UNITED STATES PATENT AND TRADEMARK OFFICE

Office Action Summary	Application No. 10/670,168	Applicant(s) VARDI ET AL.	
	Examiner ELIZABETH HOUSTON	Art Unit 3731

DETAILED ACTION

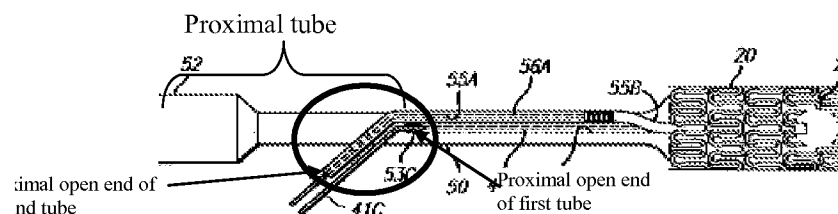
5. Regarding claim 13, Wilson discloses a catheter with a proximal tube (where the proximal tube as shown below extends from the proximal end of the catheter to the guidewire opening) and a distal *portion* comprising a first tube (53A) with a proximal open end (53C) and a second tube (55A) with a proximal open end (for example 56C). There is a bond *portion* that connects that proximal tube with the distal *portion*. The bond portion has a three-way bond that couples the proximal tube portion to the proximal open end of the first tube and the proximal open end of the second tube.

6. The first/main guidewire lumen/tube is attached to the branch/second lumen/tube external of the bond portion. The bond portion is located at a predetermined distance proximally from a proximal portion of the stent. The first and second guide wires exit at the bond portion.

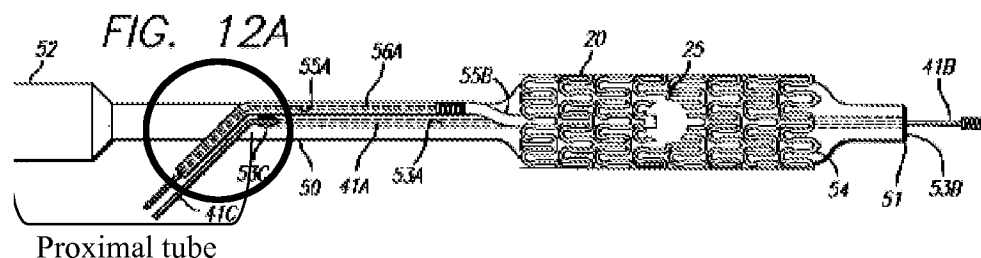
8. Wilson discloses catheter system for positioning a stent at a vessel bifurcation substantially as claimed (see entire document). Specifically, Wilson discloses a catheter

(Fig 12a-c) comprising a channel (53a) having a main guidewire lumen extending from a distal end (51) to a main exit port (53c) located at a first distance. There is a branch guidewire enclosure (55a) extending proximally from a side opening (25) of a stent (20) to a branch exit port (see for example 56c) located at a second distance. The branch guidewire enclosure is coupled to the channel adjacent (or near, close to) the branch exit port. The first and second distances of the exit ports are less than a distance from the proximal end to the distal end of the catheter and greater than a distance from the distal end of the catheter to the proximal end of the stent. The device has a balloon (54) and an inflation portion for inflating the balloon. The catheter comprises a bond portion (indicated by circle - see below) that connects the main exit port, the branch exit port and a proximal tube (where the proximal tube as shown below extends from the proximal end of the catheter to the guidewire opening).

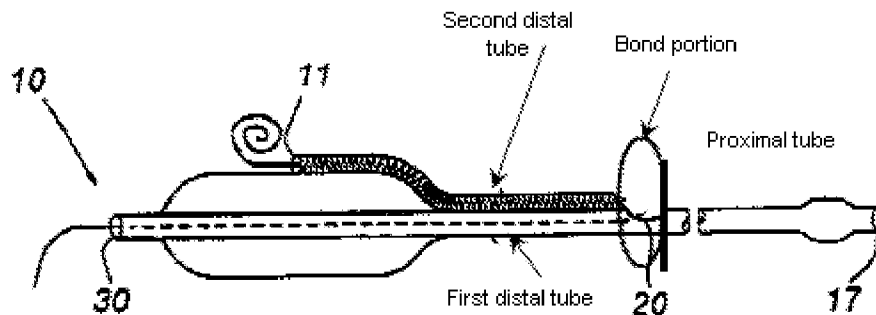
13. Wilson discloses the claimed invention as stated above except for the dimensions locating the exit openings and the length of the guidewire and the attachment along the entire length of the second lumen/tube. At the time the invention was made, it would have been obvious to a person of ordinary skill in the art to vary the size of the catheter and therefore the location of the exit ports depending on the size and location of the lumen in which it would be used. For instance catheter used on an infant would be significantly smaller than that used on a large adult. Additionally, a catheter that is being delivered to the aorta will be larger than one that is being delivered to the brain. Such a modification would have involved a mere change in the

size of a component, and a change in size is generally recognized as being within the level of ordinary skill in the art. *In re Rose*, 105 USPQ 237 (CCPA 1955).

14. Regarding claim 17, it would be obvious to one having ordinary skill in the art at the time of the invention to vary the length of the branch guide wire tube in order to produce a catheter with a more streamline profile for ease of delivery. The modified catheter would result in one where the attachment of the first and second tube is along an entire length of the second tube.
